PLEASE READ

HOOD TO TRUCK

Thank you for purchasing a Jones Performance quality truck hood.

Tilt Shock Attachment

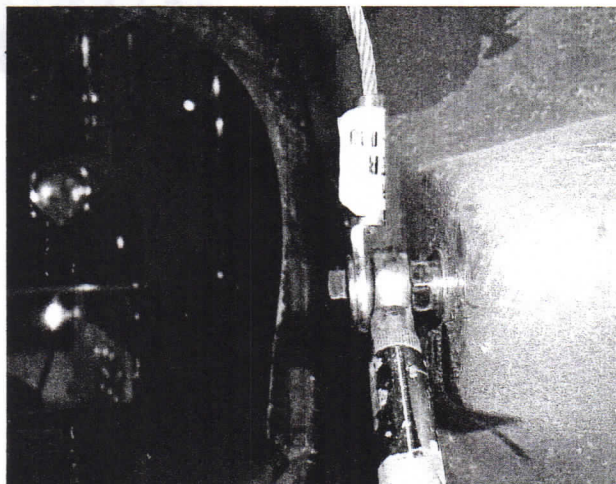
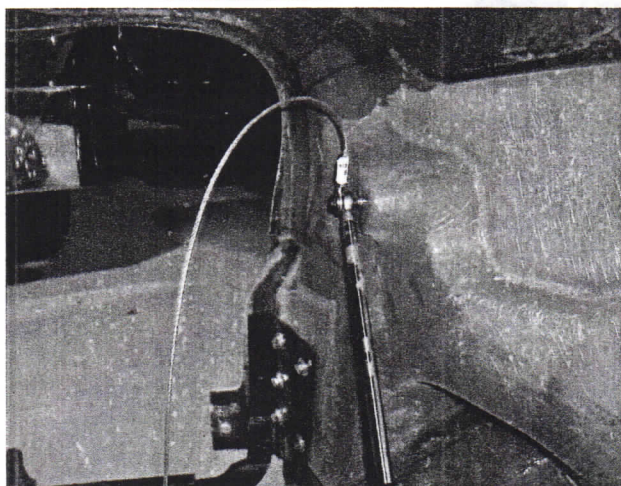
The mounting area for the tilt shock has been changed on your new JP hood. You will need to bolt your tilt shock to the innerstructure brace. See the pictures below for correct attachment.

Grill Mount

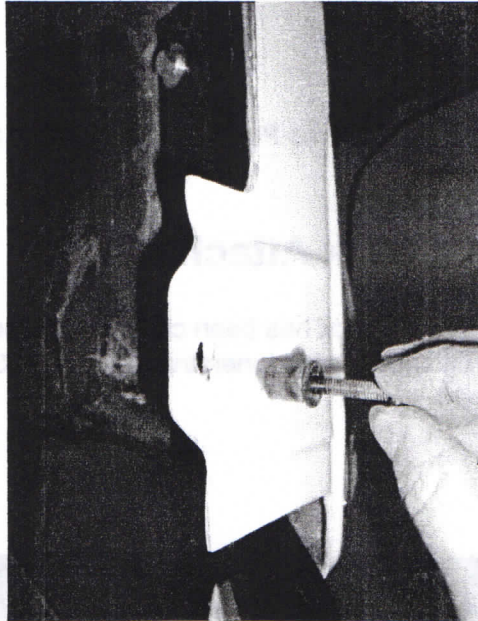
We have included two rubber well nuts. You will need to insert these into the hood before installing the grill. See the picture below for location.
